TYPE OF MEETING:	RCLU
MEETING DATE:	February 25, 2019
SEE AGENDA ITEM:	B.4

RE: Agenda Item B.4 February 25, 2019 Regular Council – Land Use
Development Variance Application No. 7918-0461-00
2155 – 166A Street

This memorandum provides direction to revise Schedule A of the planning report.

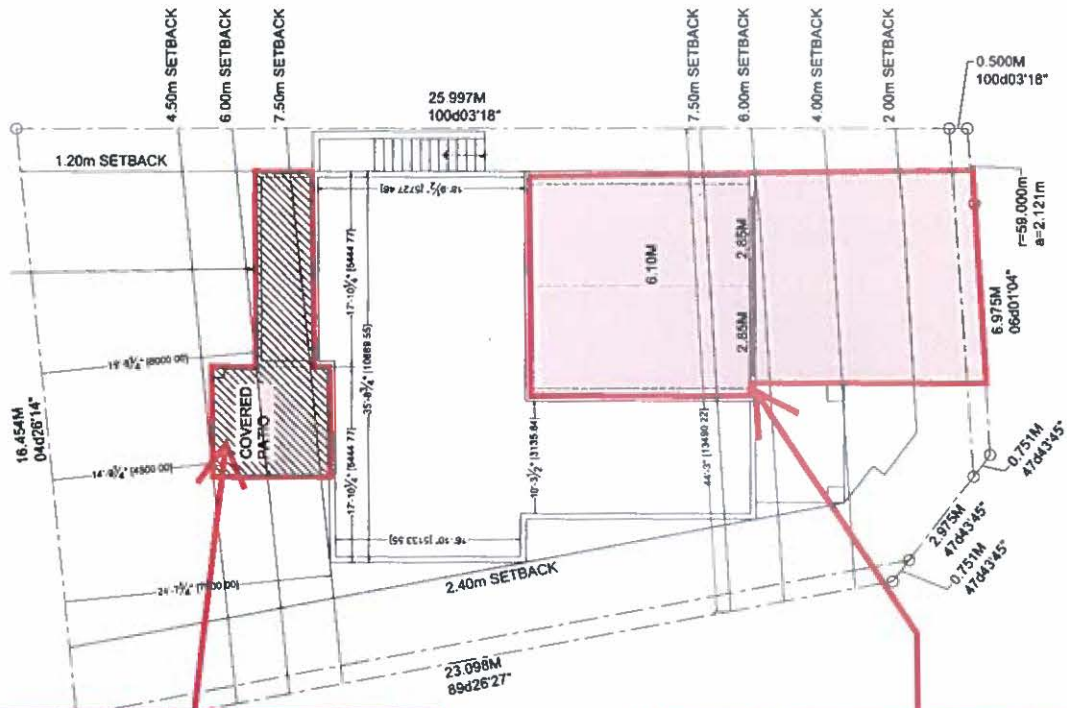
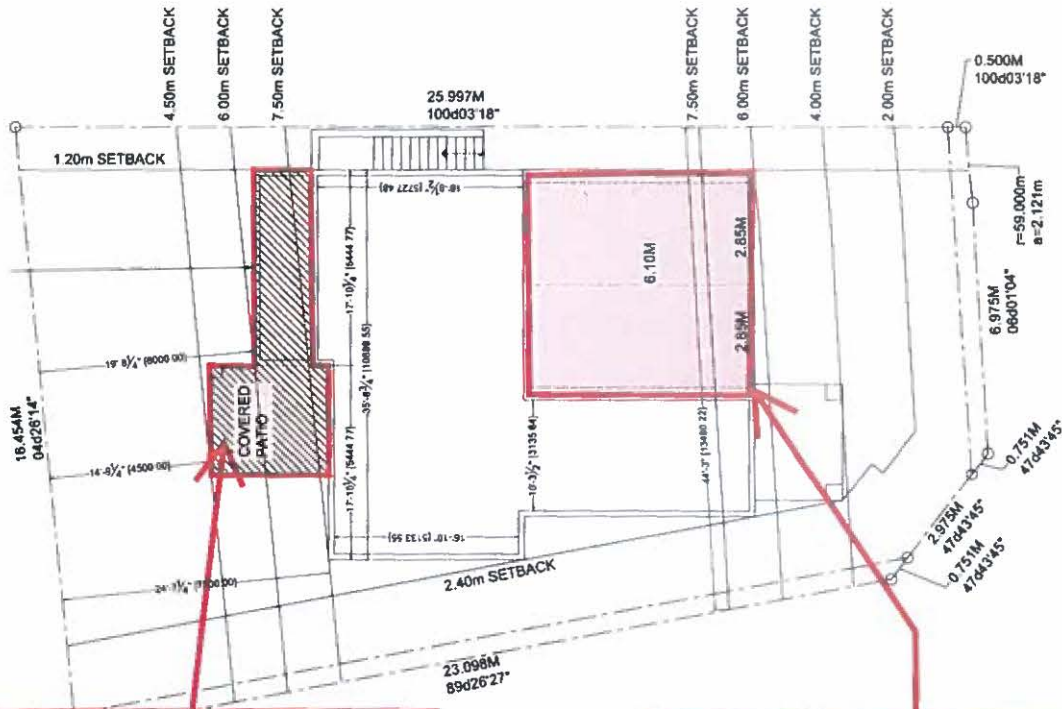
Development Variance Permit 7918-0461-00 is proposing to allow a front accessed garage that can accommodate two vehicles parked side by side. Schedule A of the planning report highlights the driveway in addition to the garage. A similar variance is being considered under Agenda Item B.5 for the property at 2191 – 166A Street. The Schedule A for this item does not highlight the driveway. These Schedules will be part of the public notification package. To improve clarity of the proposal during public notification, the Planning & Development Department recommends that Schedule A of the planning report for 7918-0461-00 is replaced to accurately reflect the proposed variance.

Attachment - Appendix A – previously proposed Schedule A
- Appendix B – amended Schedule A

variance to allow a front-accessed double car garage on a Type I corner lot

variance to allow a front-accessed double car garage on a Type I corner lot
